# Rotherhithe Cycleway consultation

## Summary Report

November 2019

Section 15 - Redriff Road (between Surrey Quays Road and Brunswick Quay)

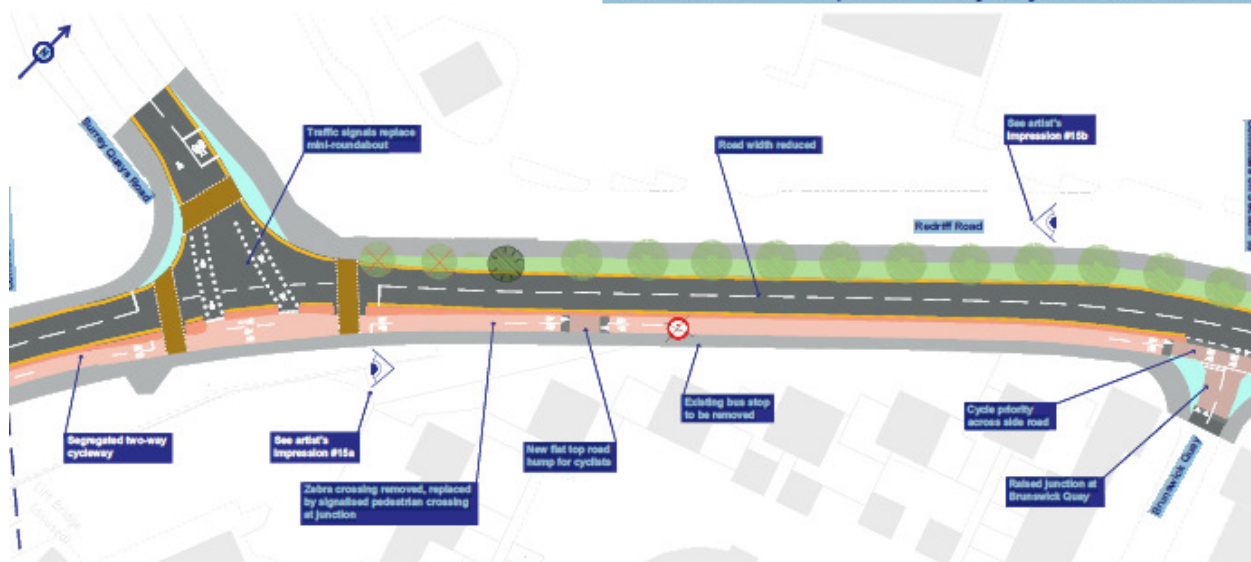
Comments and or suggestions	Response
It will be good to remove the mini-roundabout as drivers mostly go straight over it anyway. It should reduce speeds. Good to remove the bus stop as it just causes delays for other traffic plus nuisance for residents with noise and rubbish thrown over fences by bus users.	
<p>1. Traffic signals will significantly slow down local buses in the area, which are already very slow and it takes a long while to get to the nearest tube/overground stations. This adds a lot to overall commute time.</p> <p>2. Rotherhithe Street is very narrow and it's really struggling with 2 way traffic at peak times. A cycle track will only make the situation worse.</p> <p>3. The increased number of cyclists in the area will make it less safe for walking, especially for children and parents with a buggy, it will also increase the amount of garbage on the streets and will likely lead to the increased crime rate too.</p>	It is not considered likely that the introduction of a cycle route will lead to a deterioration in the cleanliness or tidiness of the area

Improve air quality	
Comments and or suggestions	Response
Cycle lane is meaningless in a street that is 1 lane each direction. Will increase traffic and queuing and increase pollution	The provision of safer cycle facilities will give people the opportunity to cycle rather than drive, which will assist in the improvement of air quality
it's not a very busy road so not sure a traffic signal is needed? Will only cause more traffic / cars standing still therefore more pollution	
I do not support any plan that seeks to encourage cyclists onto the roads carrying buses and lorries and major traffic flows . This is only encouraging them onto the roads with the traffic most likely to kill them. Better to create cycle routes by the river or through parks and nature reserve. Or failing that through side streets. <b>Messing up Redriff road for traffic will create higher pollution .</b>	
Ooops. No chance of ever moving along the road then. My God, my asthma problem is guaranteed to get far worse than it is already. Loss of ai-cleaning trees as well. UTTERLY GHASTLY.

Crossing roads is easy and safe	
Comments and or suggestions	Response
Good to see better crossings for pedestrians	
Looks much safer for cyclists and pedestrians	
<p>The placement of the Zebra crossing matches the path from Brunswick Quay and the pedestrian entrance to the cinema. It should be kept where it is. People will cross here anyway rather than needlessly walking to your proposed new crossing.</p> <p>There is also not enough traffic or footfall on this area to warrant a signalled pedestrian crossing here. The zebra crossing works just fine.</p> <p>I also strongly oppose the removal of the mini roundabout. This is not a busy junction and traffic signals will just cause delays. The roundabout works extremely well right now. You seem obsessed with signals throughout all the recent plans.</p> <p>I also strongly oppose the kerb on the segregated cycleway. This will make crossing the road with a pram very difficult.</p> <p>I personally do not use this bus stop, but why is it removed? Where do brunswick quay residents get their bus?</p> <p>I also strongly oppose the kerb on the segregated cycleway. This will make crossing the road with a pram very difficult.</p>	<p>The new crossing point is x metres from the existing crossing and will cater for those pedestrians heading towards Surrey Quays Road. The entrance into this site will no longer exist once this area is developed. So this design future proofs works when developments take place</p> <p>A zebra crossing so close to a signal junction would cause confusion and as a result would be unsafe</p> <p>New crossing are proposed along the route to allow pedestrians to cross Redriff Road and Salter Road</p>

Easy and safe to cycle	
Comments and or suggestions	Response
<p>Principle of promoting cycling is supported. Cycle lanes generally seem quite narrow, and would ideally be wider. Concerned by side roads pulling out into two way cycle traffic. These number of roads pulling out into cycle lanes should be limited to as few as possible to minimise the chance of collisions.</p>	<p>The width of the cycleway has been dictated by available space and the desire to minimise its effects particularly with regards to trees</p>
<p>Is it possible to also place a cycle lane along surrey quays road? even if its not segregated, a marking on the road would be beneficial.</p>	<p>This will be investigated</p>
<p><b>"New flat top road hump for cyclists": Why is this necessary?</b></p> <p>Why remove the "left"-most trees? These are mature trees.</p>	<p>The flat top hump is to avoid the expense of relocating a BT cover. This will be further explored during detailed design.</p>

There are a lot of daffodils planted under the grass verge on this section. I am not clear whether you plan to reduce the width of these verges or dig them up, but it would be a shame to lose the daffodils. If the contractors are due to dig up the verges or reduce their width can they be asked to put the daffodil bulbs to one side and then replace them when they put the earth back again?

These plans look great! As long as the grassy surface on the left hand side of the artist's impressions can be retained.	
Strongly support the cycle track, though loss of trees is sad.	
If two tree will be removed the council should have at least 4 new trees in the area.	
I oppose the changes because it means the loss of a significant green verge and many trees. I know the plan notes that there will be a net gain in trees, but these will be in different locations to those that will be removed. This will change the quality of the street and walking environment. More trees, planting and landscaping should be provided to mitigate the proposed loss, not elsewhere but in the same locations and proximity to the loss.	
I like the segregated cycleway but I am concerned by the two pedestrian crossings that cut across it. Could it not be like the Cycleway on the Embankment where there is a separate crossing for the cycleway and for the roads? In practice pedestrians can safely cross the Cycleway there without pressing the crossing button in most cases,

"New flat top road hump for cyclists": Why is this necessary?	
Why remove the "left"-most trees? These are mature trees.	
I oppose the removal of the trees.	
Oppose the removal of mature trees	
Loss of two trees is sad but segregated cycle path is most important	
Please plant an extra replacement tree as close as possible	
Please consider planting more trees	
Good to have separate cycle route and if you can't sort out a dedicated proper cycling route and put cyclist on road, good to have an advance light.	The buffer zone is only 0.5metres wide and is of sufficient width to accommodate planting
But buffer zone, this needs planting, could be integrated suds system.

The verge is slightly narrowed at this point the daffodils look like they are close to the kerb. New daffodils will be replanted

At the next design stage we will continue this and investigate opportunities to plant additional trees

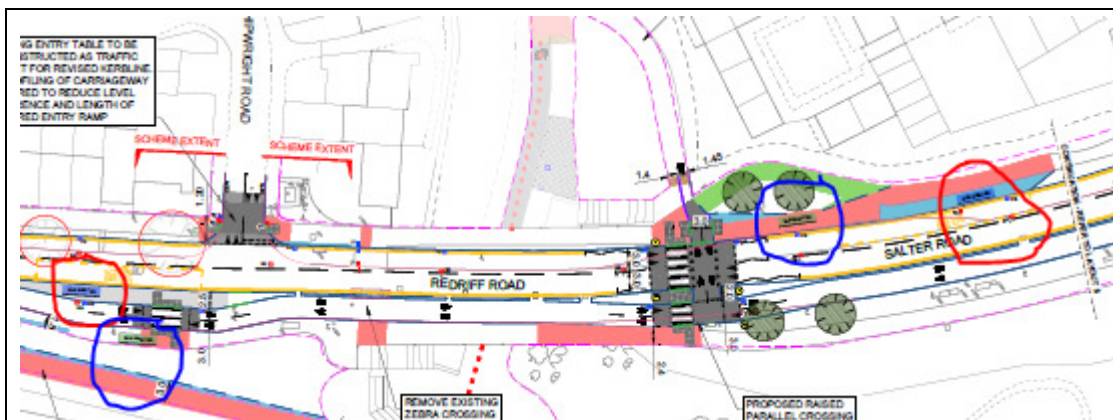
Comments and or suggestions	Response
<b>Norway Gate</b>	
Risk of vehicles turning into Norway Gate colliding with people on bikes. The turning radius is not tight enough meaning that drivers can't see cyclists approaching from 'behind' them as they turn. Either the turning radius needs to be tighter by extending the protective kerb nearer the junction or setting the cycleway further back from Redriff Road so that drivers approach the cycleway at 90 degree angle.	The design of the minor junctions (Norway Gate)) where they meet\ cross the Cycleway, is governed by the availability of road space. The designs have incorporated raised surfaces, small radius at the junction and continuation of the segregation as close to the junction as possible. At the detailed design stage this will be checked again.  Once works commence a public awareness programme will take place, explaining to local residents how these junction layout should used.

Support the narrowing of the mouth of the junction with Norway Gate	
There are some quite imaginative changes here and I like the connections to QW14. Fully support the cycleway having priority over the junctions and the joint pedestrian-Cycleway zebra crossing.	
<b>I oppose cycle priority across side roads</b> and cyclists using pedestrian path to Quietway 14.  I oppose commingling cyclist crossing point with pedestrian zebra crossing. These two should be kept separate and a cyclist crossing should not have priority over cars driving on Salter Road /	A cyclist having priority across a side road is no different than the existing road layout, vehicles turning in or out of Norway Gate, would be expected to give way to cyclists on Redriff Road. The only difference it that the cycleway has two way flow.

Redriff Road.	
Raise road on Norway gate unnecessary	<p>The raised road into Norway Gate has benefits for cyclists and pedestrians. For pedestrians, particularly those with pushchairs etc, the road and footway at the same level will assist them crossing.</p> <p>For all road users it will help reduce the speed of traffic leaving Salter Road.</p> <p>It also give drivers a visual message to take care</p>
<p>These changes Segregated two-way cycleway on the south side of Salter Road</p> <p>Connection proposed to Quietway 14</p> <p>New raised crossing for cyclists</p> <p>Cycle priority provided across Norway Gate through raised junction to reduce the speed of turning traffic will make it safer for cyclists.</p>	<p>A cyclist having priority across a side road is no different than the existing road layout, vehicles turning in or out of Norway Gate, would be expected to give way to cyclists on Redriff Road.</p> <p>The only difference it that the cycleway has two way flow</p>

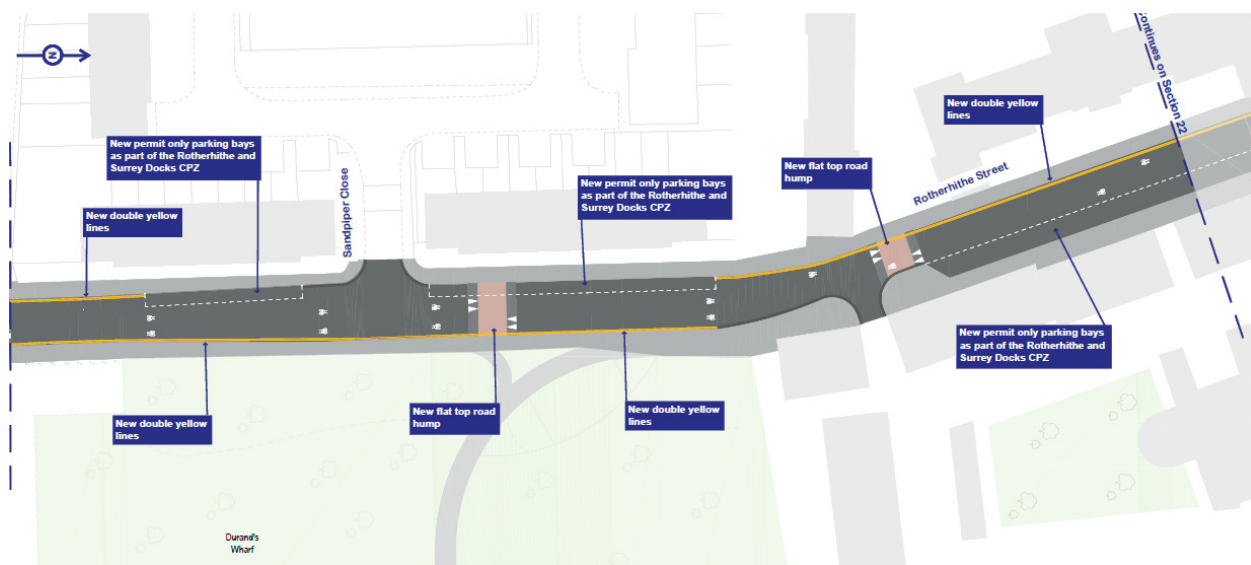
Comments and or suggestions	Response
<p>I support the introduction of parking restrictions all along Rotherhithe Street as the current situation with parking permitted on both sides in the same area has been unworkable for years and many representations to the area councillor have been ignored.</p> <p>C10 buses are often unable to squeeze past cars on either side and when 2 buses arrive in the same area grid lock occurs.</p> <p>I do not support speed humps as they make bus travel seriously uncomfortable ... if controlling speed is an issue then installing speed cameras is as effective without impairing comfortable travel for responsible drivers and bus passengers.</p> <p>Why is there a protruding pavement at the bus stop? ... these reduce the road's width and contribute nothing to embarking/alighting from the bus ... and they stop drainage with the result the road floods exaggerated in negative impact by utter failure by Southwark Council in clearing blocked gulleys.</p>	<p>Blocked gulleys will be investigated when the road is resurfaced</p>

Existing flat top road hump next to hollyoake	This road hump is to be replaced with a asphalt
